Well Name: COTTON DRAW 32
STATE FED COM

Well Number: 1H

Notice of Intent

Type of Action: Plug and Abandonment

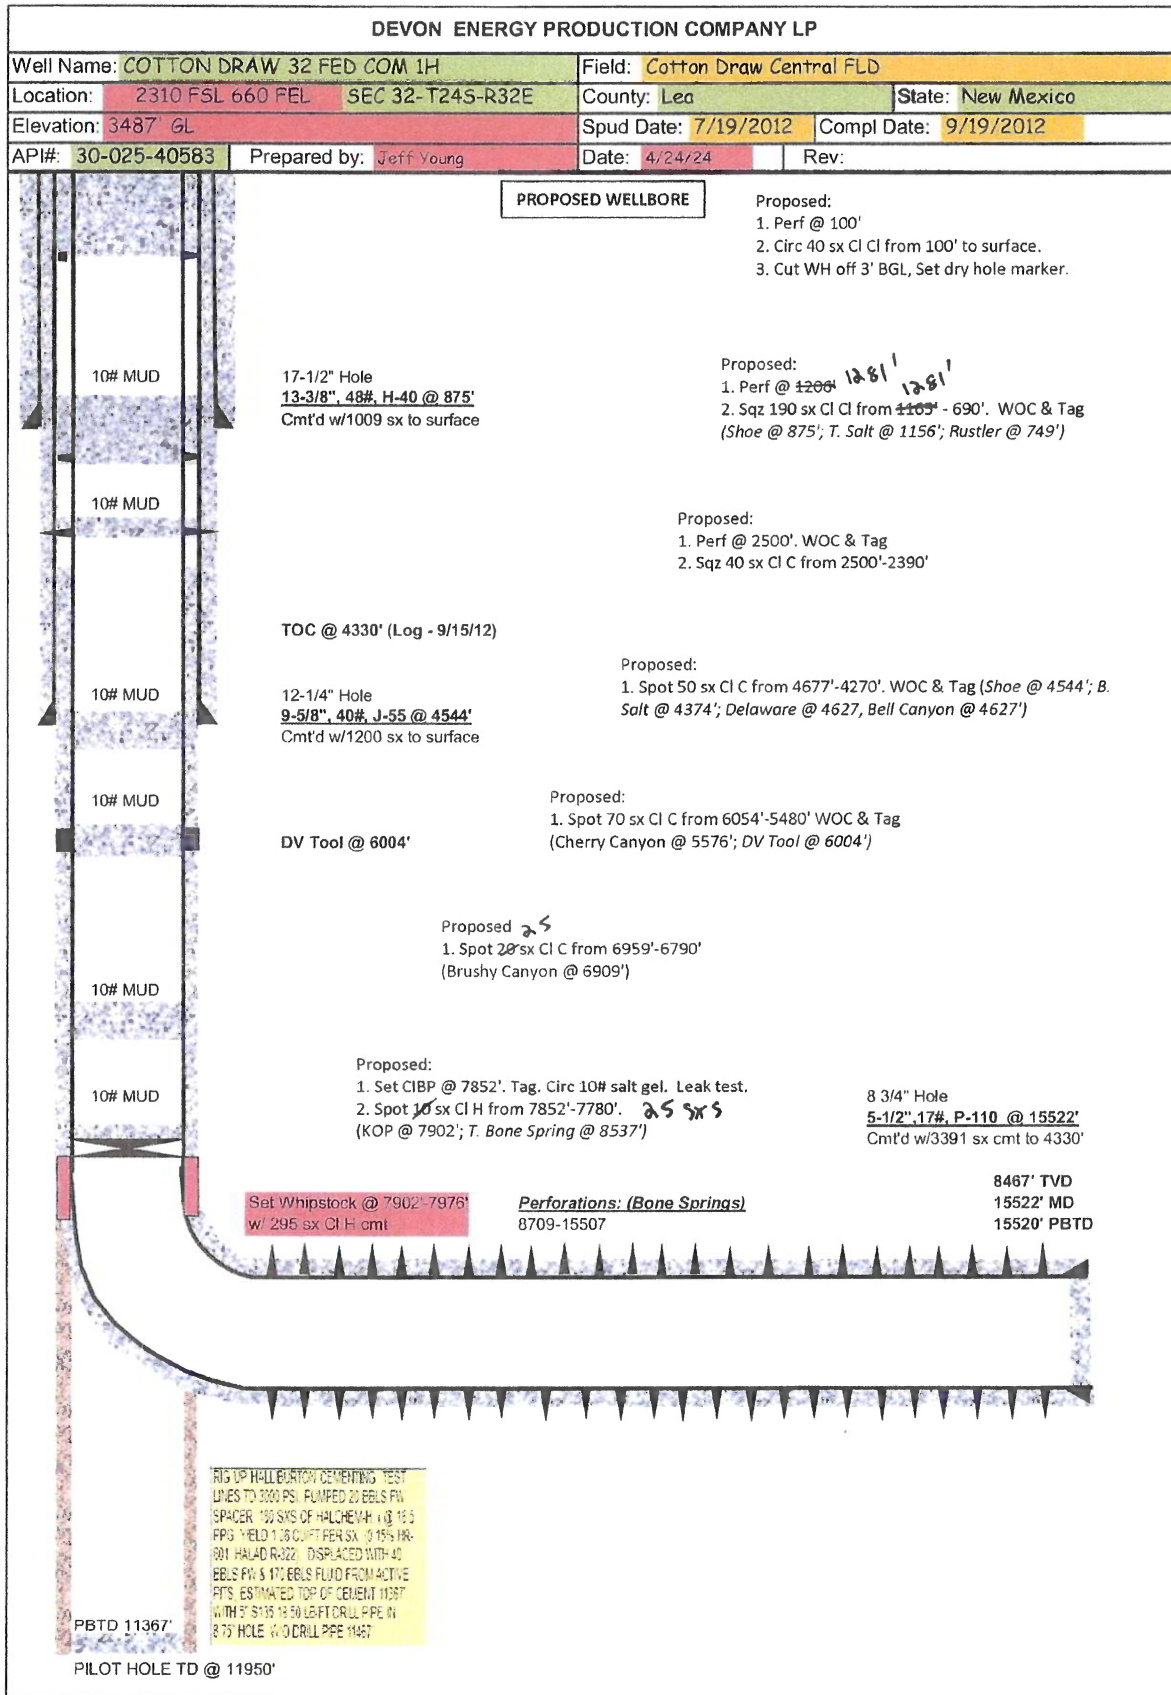
1. MIRU P&A unit. TOOH w/ Rods and Tbg from 7894'
2. Set CIBP @ 7852'. Tag. Circ 10# salt gel. Leak test.
3. Spot 10 sx Cl H from 7852'-7780'. (KOP @ 7902'; T. Bone Spring @ 8537')
4. Spot 20 sx Cl C from 6959'-6790' (Brushy Canyon @ 6909')
5. Spot 70 sx Cl C from 6054'-5480' (Cherry Canyon @ 5576'; DV Tool @ 6004')
6. Spot 50 sx Cl C from 4677'-4270' (Shoe @ 4544'; B. Salt @ 4374'; Delaware @ 4627'; Bell Canyon @ 4627')
7. Perf @ 2500'; Sqz 40 CL C from 2500'-2390'
8. Perf @ 1206'; Sqz 190 CL C from 1206'-690' (Shoe @ 875'; T. Salt @ 1156'; Rustler @ 749')
9. Perf @ 100'; Circ 40 sx Cl Cl from 100' to surface.
10. Cut WH off 3' BGL. Set dry hole marker.

Plug Type	Top	Bottom	Length	Tag	Sacks	Cement Class	Notes
Surface Plug	0.00	100.00	100.00	Tag/Verify	30.00	C	Perforate and squeeze from 100' to surface. Verify at surface. (In 10 sxs/Out 20 sxs)

13.375 inch- Shoe Plug	816.25	925.00	108.75	Tag/Verify			
Top of Salt @ 1156	1094.44	1281.00	186.56	Tag/Verify	138.00	C	Perforate and squeeze from 1281' to 816'. WOC and Tag. (In 46 sxs/Out 92 sxs)
Base of Salt @ 4374	4280.26	4424.00	143.74	Tag/Verify

9.625 inch- Shoe Plug	4448.56	4594.00	145.44	Tag/Verify			
Delaware @ 4627	4530.73	4677.00	146.27	If solid base no need to Tag (CIBP present and/or Mechanical Integrity Test), If Perf & Sqz then Tag, Leak Test all CIBP if no Open Perforations	40.00	C	Spot cement from 4677' to 4280'. WOC and Tag.
DV tool plug	5893.96	6054.00	160.04	Tag/Verify	25.00	C	Spot cement from 6054' to 5893'. WOC and Tag.
Brushy Canyon @ 6909	6789.91	6959.00	169.09	If solid base no need to Tag (CIBP present and/or Mechanical Integrity Test), If Perf & Sqz then Tag, Leak Test all CIBP if no Open Perforations	25.00	C	Spot cement from 6959' to 6789'.

If solid base no need to Tag (CIBP present and/or Mechanic al Integrity Test), If Perf & Sqz then Tag, Leak Test all CIBP if no Open Perforatio ns			
CIBP Plug	7817.00	7852.00	35.00		25.00	H	Set CIBP at 7852'. Spot 25 sxs on top. Leak test CIBP.
Perforations Plug (If No CIBP)	8659.00	15557.00	6898.00	Tag/Verify			
5.5 inch- Shoe Plug	15316.78	15572.00	255.22	Tag/Verify
